SAN RAFAEL CITY SCHOOLS
310 Nova Albion Way, San Rafael 94903

ADDENDUM NO. 1
TO
Short Elementary School Early Childhood Education (ECE) Development
BID # 24-08
Addendum Date: 3/14/24

Bid Addendum No. 01

Project: Short ES ECE Development Center
Client: San Rafael City Schools
Project No.: 2023-014.00
DSA A#: 01-121552

Item 1.2 – Refer to: C2.0 – Demolition Plan

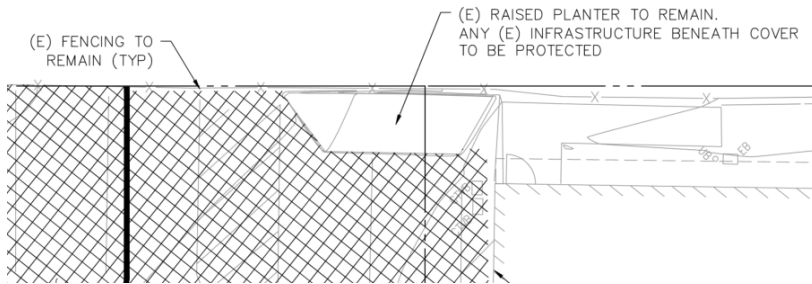
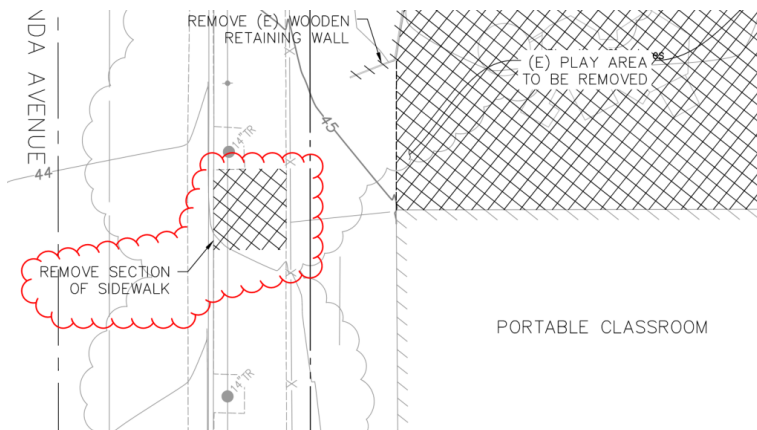
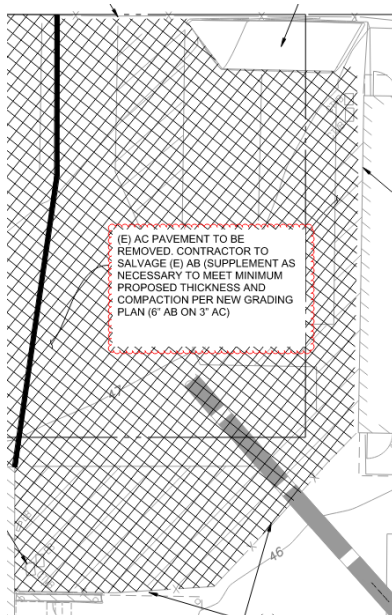
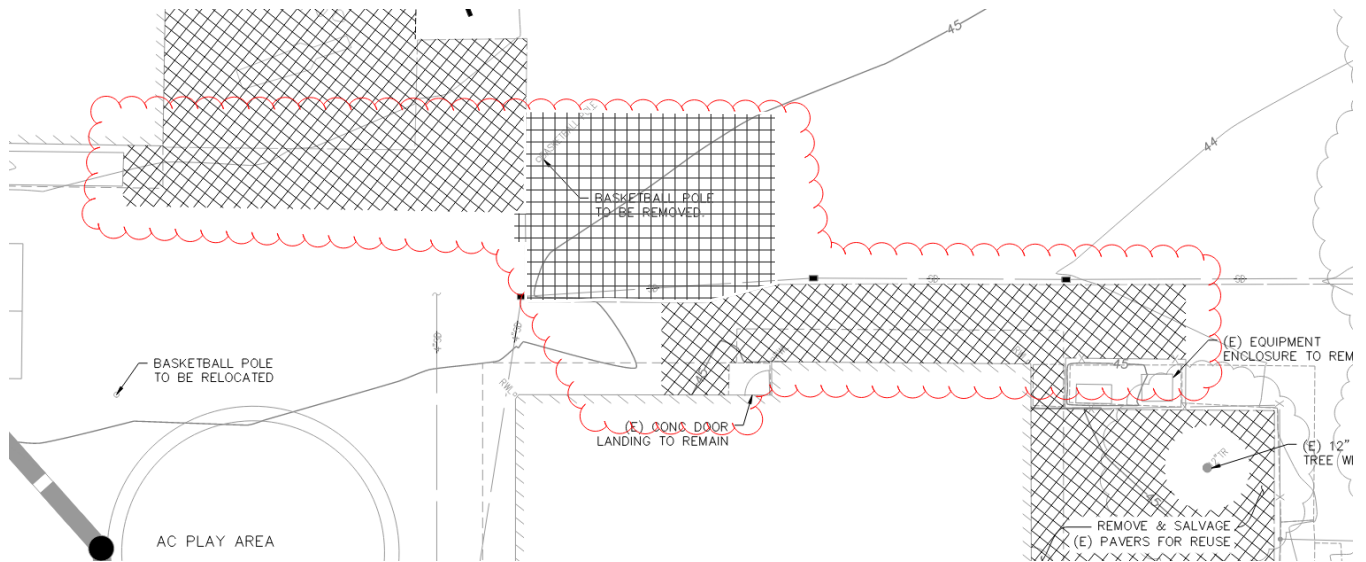
1.2	C-2.0	<ol style="list-style-type: none">1. Parking lot updated to show (E) Planter as remaining.2. Added note to remove section of (E) Sidewalk and indicated the extend of (E) removal.3. Updated note to define removal of AC paving and AB to remain at parking lot.4. Drawings updated to show new demolition work by field.

1. Parking lot updated to show (E) Planter as remaining:

2. Remove Section of Sidewalk:

3. Updated note to define removal of AC paving and AB to remain:

4. Drawings updated to show new demolition work by field.

Item 1.3 – Refer to: C-3.0 – Grading Plan

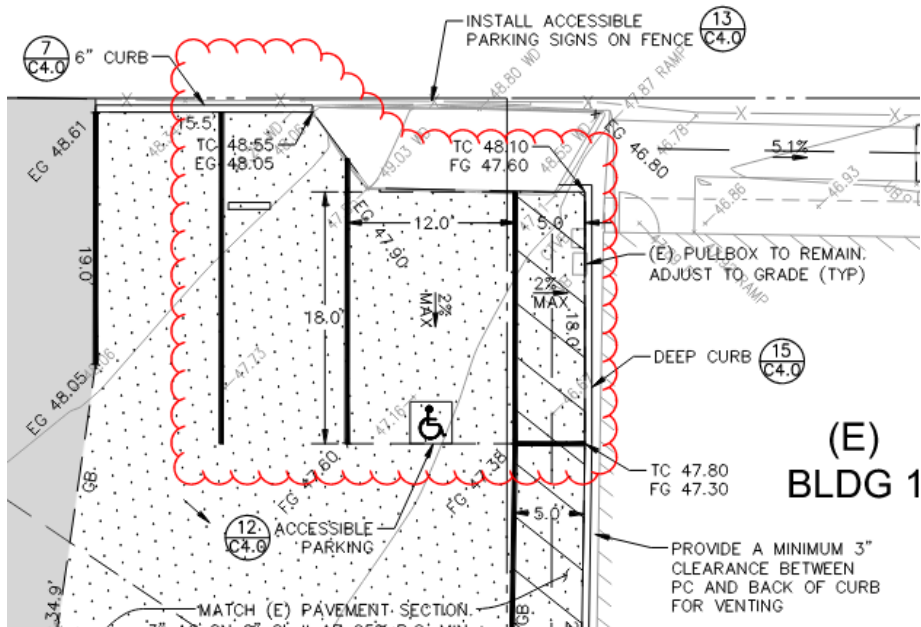
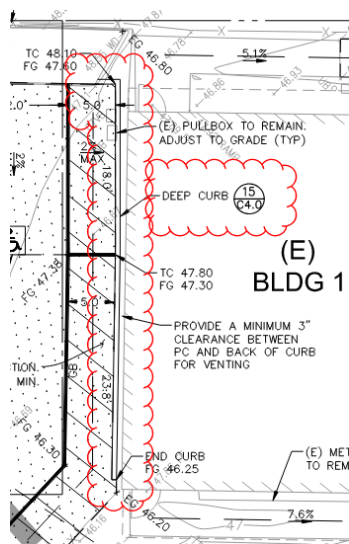
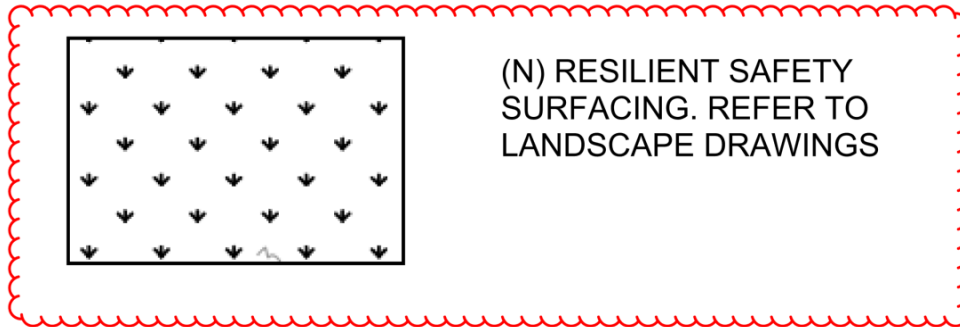
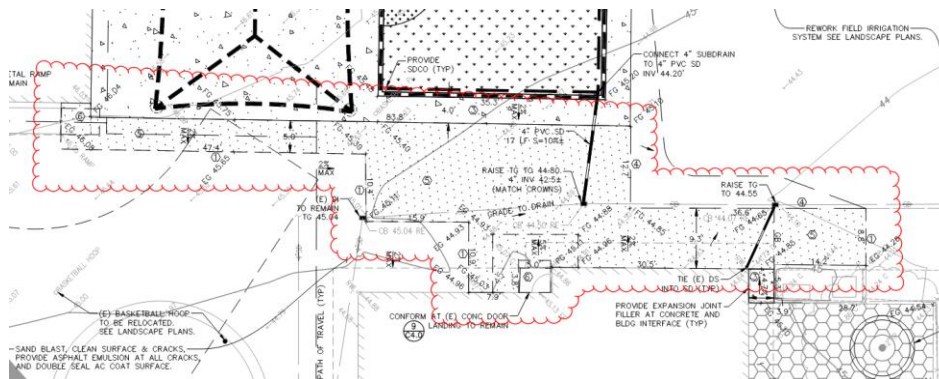
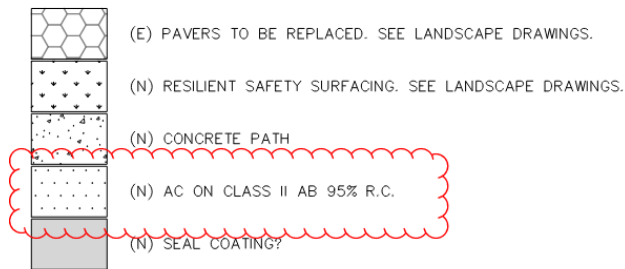
1.3	C-3.0	<ol style="list-style-type: none">1. Updated accessible parking stall layout to indicate the (E) raised planter to remain. Updated detail references to reflect these changes.<ol style="list-style-type: none">a. New curb alongside building 'C', see detail 15 / C-4.02. Added hatch to indicate the extend of sidewalk repair.3. Updated grading points adjacent to field.

<ol style="list-style-type: none"> Fixed hatch description from “grass” to “Resilient Safety Surfacing” to match Landscape drawings. Resilient safety surfacing to be OFOI (Owner Furnished Owner Installed). Updated legend to show “(N)AC on Class II AB 95% R.C” for dotted regions.

- Updated parking lot access stall layout to account for (E)Raised Planter:

- New curb alongside Bldg. 1, see detail 15 / C-4.0 for deep curb.

4. Fixed hatch description from “grass” to “Resilient Safety Surfacing” to match Landscape drawings.

Resilient safety surfacing to be OFOI (Owner Furnished Owner Installed):

5. Updated surface material legend to show “(N)AC ON CLASS II AB 95% R.C” for dotted regions.

Item 1.4 – Refer to C-4.0 – Construction Details

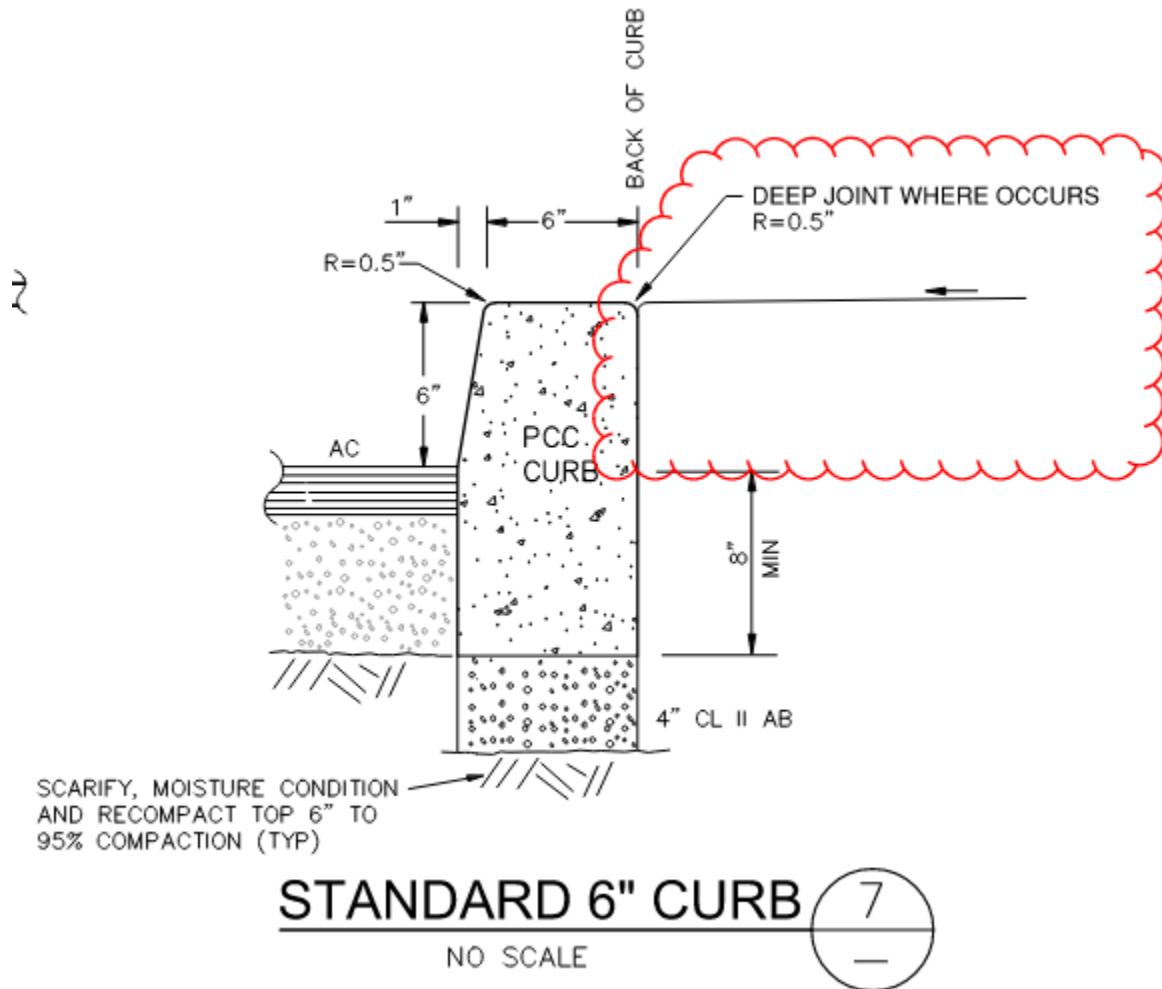
- Updated detail for typical application at multiple locations. Wording updated to read “ deep joint where occurs.”

Item 1.5 – Refer to A1.1 – Demo Site Plan

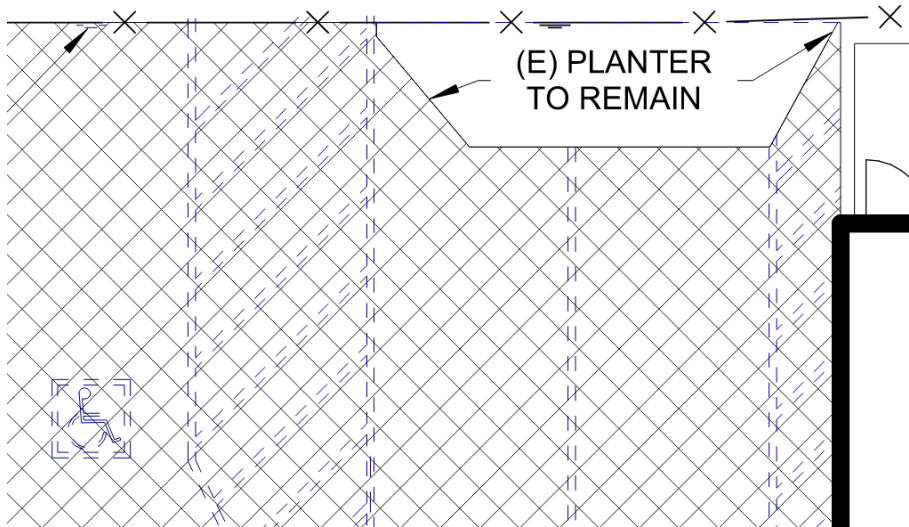
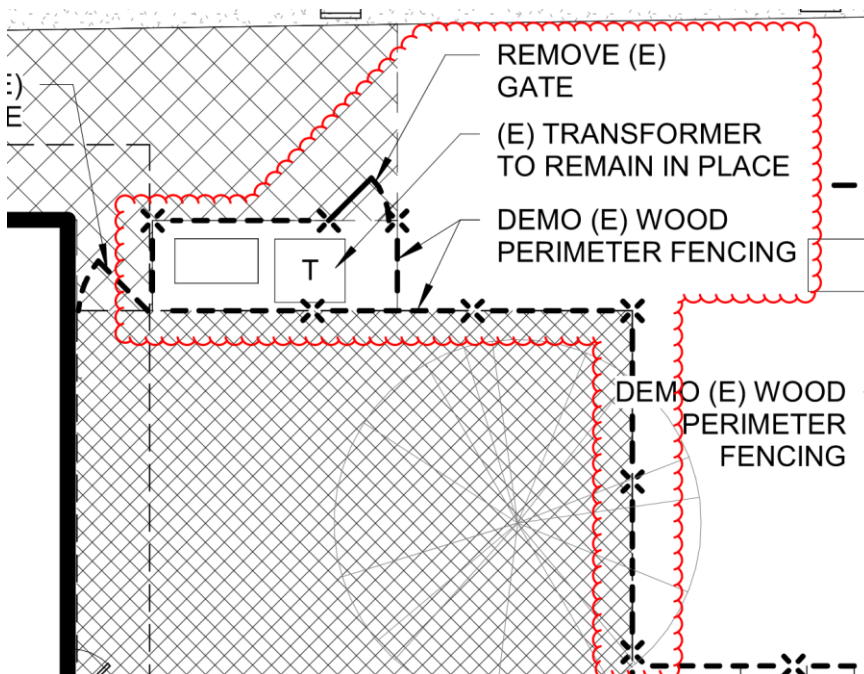
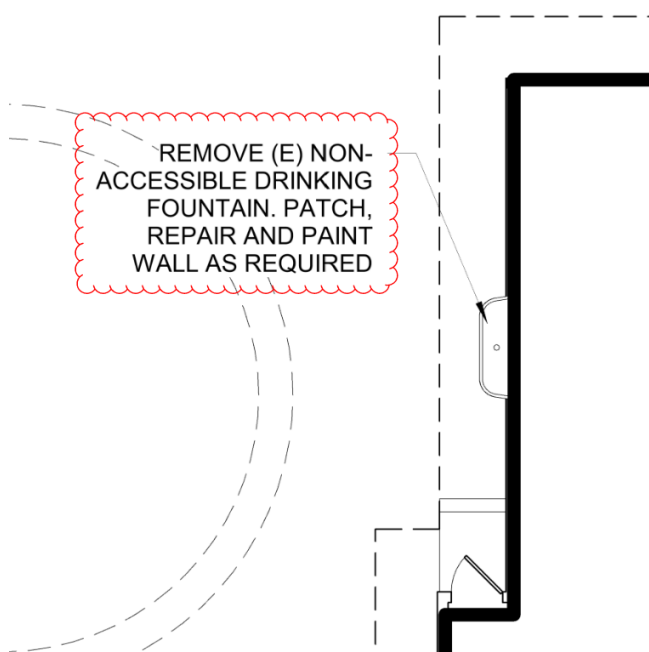
1. (E) Raised plated to remain in parking lot, no longer part of demolition scope:

2. Updated fence demolition work to include all wooden fencing and gate by courtyard and transformer next to building 'A':

3. Added new general note for new surfacing at portable classroom ramps:

REMOVE (E) SURFACE AT ALL (E) PORTABLE CLASSROOM RAMPS. CLEAN AND PREPARE FOR NEW SLIP RESISTANCE SURFACE. PROTECT IN PLACE (E) HANDRAILS.

4. Added note to indicate removal of (E) non-accessible drinking fountain at building 'A.' Note added to "patch, repair and paint wall as required":

Item 1.6 – Refer to A1.2 – Campus Site Plan

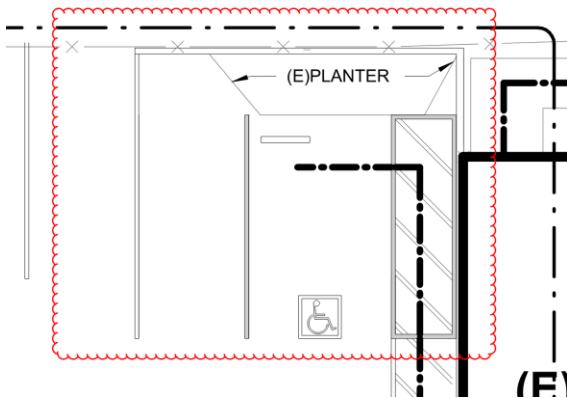
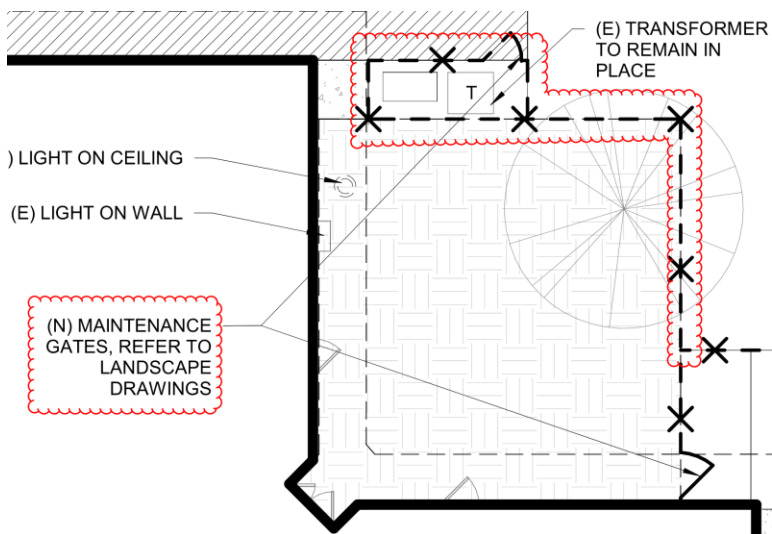
1. Adjusted accessible stall striping to show (E) raised planter:

2. New chain-link fencing and maintenance gate added by courtyard and transformer at building 'A':

3. Added note to indicate new surface at all portable ramps:

PROVIDE (N) SLIP RESISTANCE SURFACE @ ALL PORTABLE RAMPS. PROTECT IN PLACE SURROUNDING (E) HANDRAILS AND (E) WALLS TO AVOID OVERSPRAY.

SHERWIN WILLIAMS - RESUGRIP 150 (MEDIUM GRAY)

Item 1.7 – Refer to A1.3 – Enlarged Plans and Details

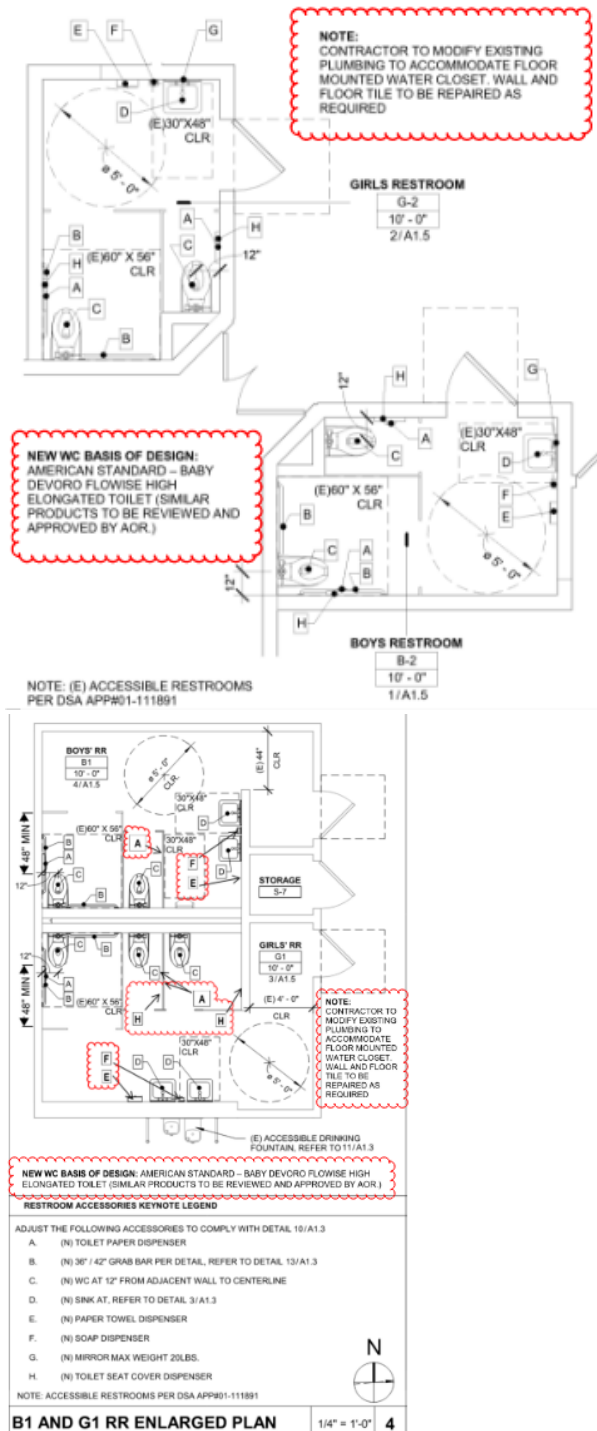
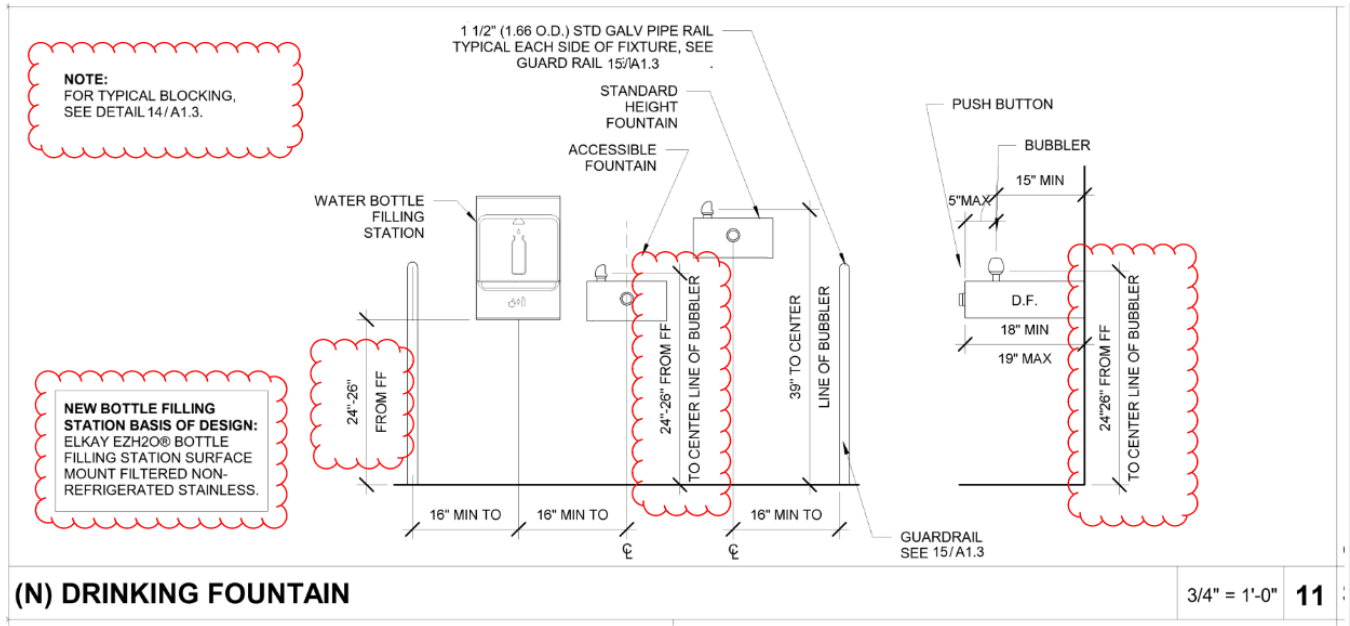
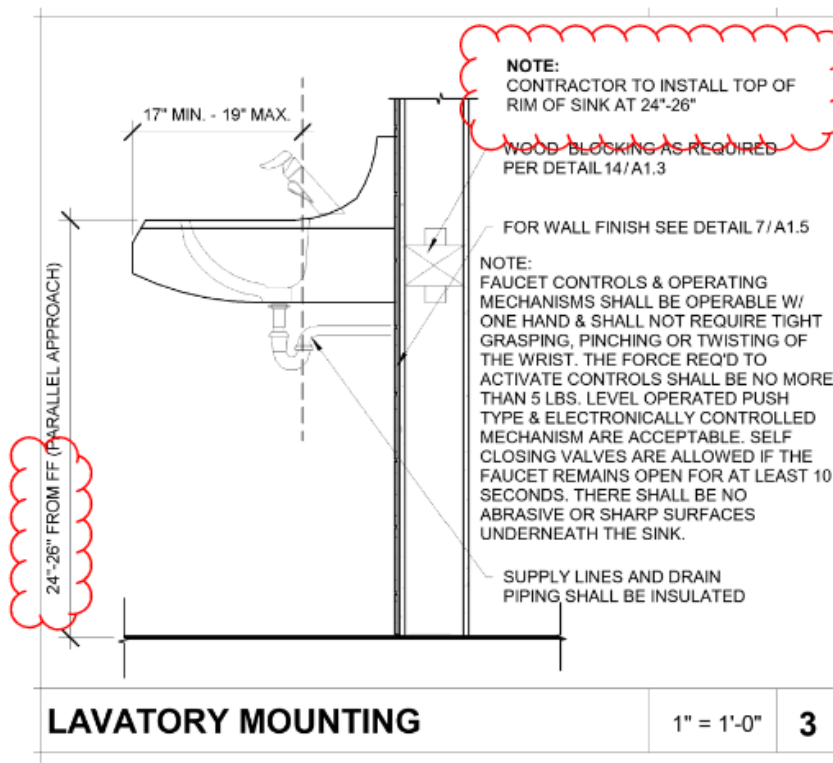
- TK Water Closets basis of design has been updated to: American Standard – Baby Devoro FloWise High Elongated Toilet (Mounting height should not exceed 12” from finish floor to seat of water closet) New water closet installation note added:

- Detail 11/A1.3 updated to show drinking fountain with bottle filling station:

Note: Children's drinking fountain to be at 24"-26" from finish floor if CL of spot is 3 1/3" max from edge.

- Detail 3 / A1.3 updated with note for contractor to install sink rim at 26-24 inches.

Item 1.8 – Refer to A1.5 – Interior Elevations

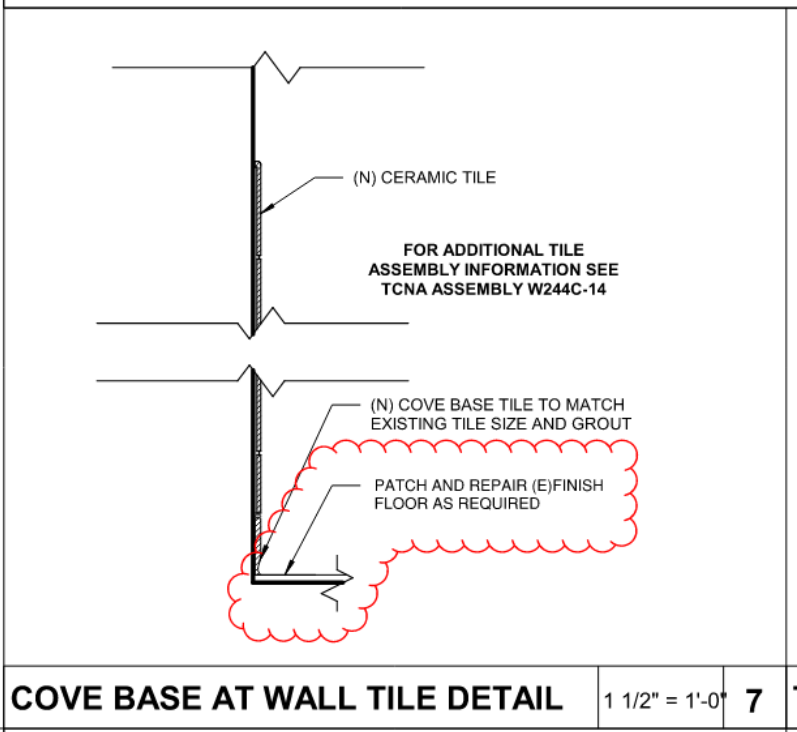
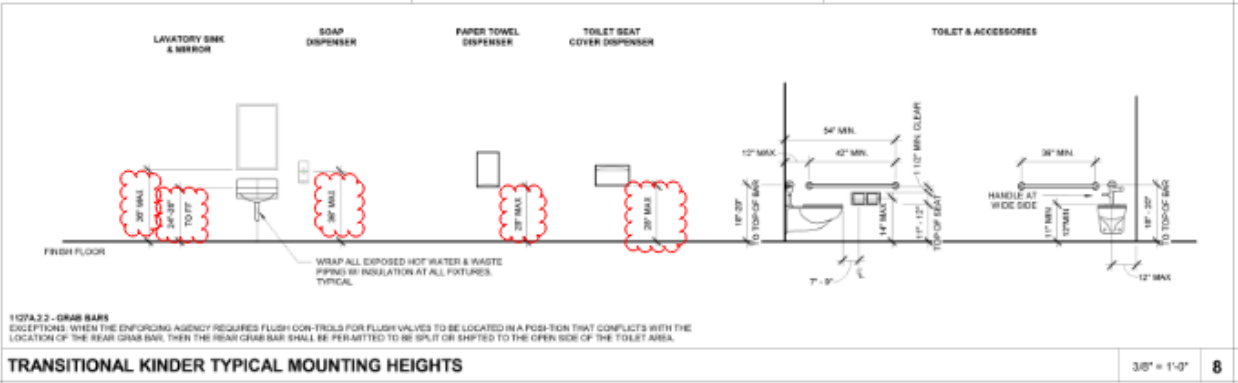
1. Updated detail 7 / A1.5 to patch and repair (E) finish floor:

2. Updated detail 8 / A1.5 with new fixture mounting heights for mirror, soap dispenser, paper towel dispenser, and toilet seat dispenser to read as follows:
